**DAUPHIN COUNTY SUBDIVISION/LAND DEVELOPMENT REVIEW REPORT**

Municipality	West Hanover Township		Surveyor	Act One & Associates		Engineer	Integrated Consulting		
Plat Title	Manor Drive Development								
Zoning District	R-1 Low-Density Residential; R-2 Medium-Density Residential				Proposed Land Use	Residential			
<b>Plat Status:</b>	Preliminary	<b>Plat Type:</b>	Subdivision	<b>Regulations:</b>	County				
	Final		Land Development		X	Municipal			
	X P/F		X Combined		X	Zoning			
	Minor				X	S&LD			
# of Lots	2	# of New Lots	32	# of DUs	29	Acs Subdiv/Devel	S: 49.27 D: +/-24	Total Acs	49.27
Date Received	10-02-2025	Staff Review	10/16/2025		Official County Review	10/16/2025

**Project Description:** Subdivision of land for residential development.

**Plan No. 25-107**

**SITE PLAN -  
OVERALL**

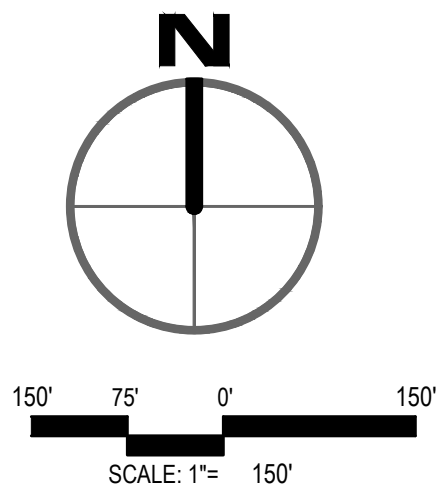
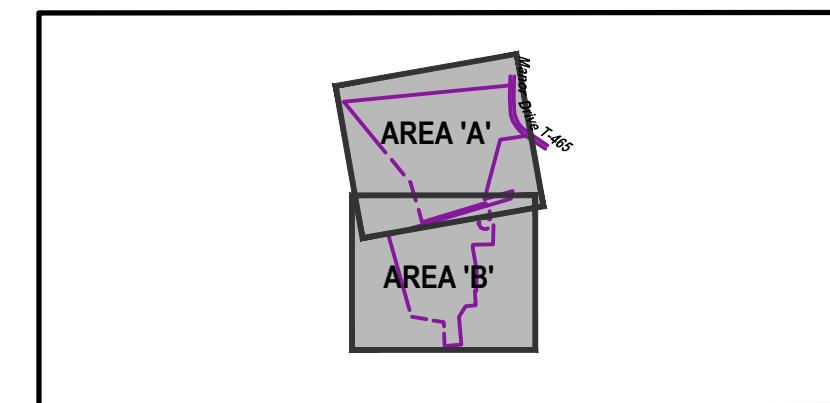
1. Has there been any consideration for having a pedestrian access easement, sidewalks, etc. that connect to the Central Dauphin High School property to the west?
2. It seems like the sidewalks are placed non-continuously throughout the development.
  - a. Consider having a more continuous sidewalk network throughout the development.
3. Is there a planned emergency access drive?
4. Is a pedestrian easement required for the walking path the runs south from Country Manor Road and subsequently connects to what I assume is an existing walking path.
5. Additional permits may be required for the proposed roads to traverse wetlands and streams on the property.
6. Lot 29 looks as though it has a large portion of the lot is covered by wetland. Is any of the space going to be usable to them?
